MSOX3012A-03

S E R V I C E N O T E

MSOX3012A – Oscilloscope, Mixed Signal, 2+8 Channel,
100MHz

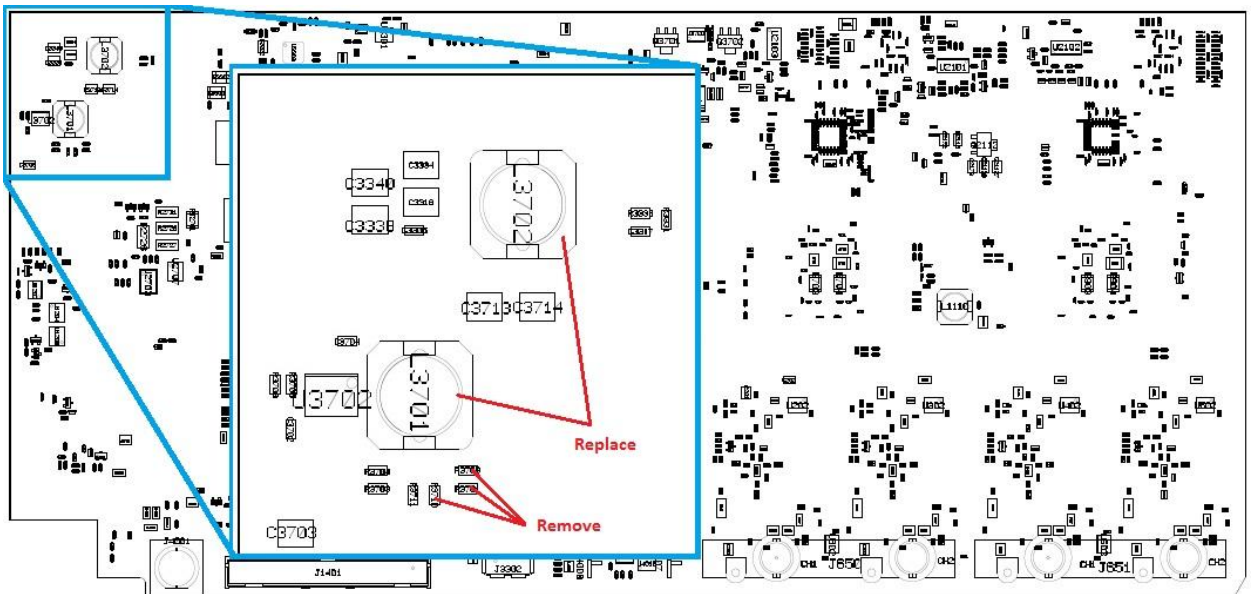
With the oscilloscope power turned on and while under normal operation, the unit emits a hissing noise.

2. As the picture indicates, remove the three resistors (0699-7209, 1 Ohm) located at R3701, R3709, and R3710. They are not to be replaced.
3. Remove as well the two inductors (9140-6474, 100uH) located at L3701 and L3702 and replace them with inductors with part number 9140-6151 (68 uH).
4. Re-assemble to the point where the unit could be powered up to verify that the hissing is indeed gone. If the hissing is not gone, please, check modifications.
5. When the hissing is gone, put oscilloscope back together.
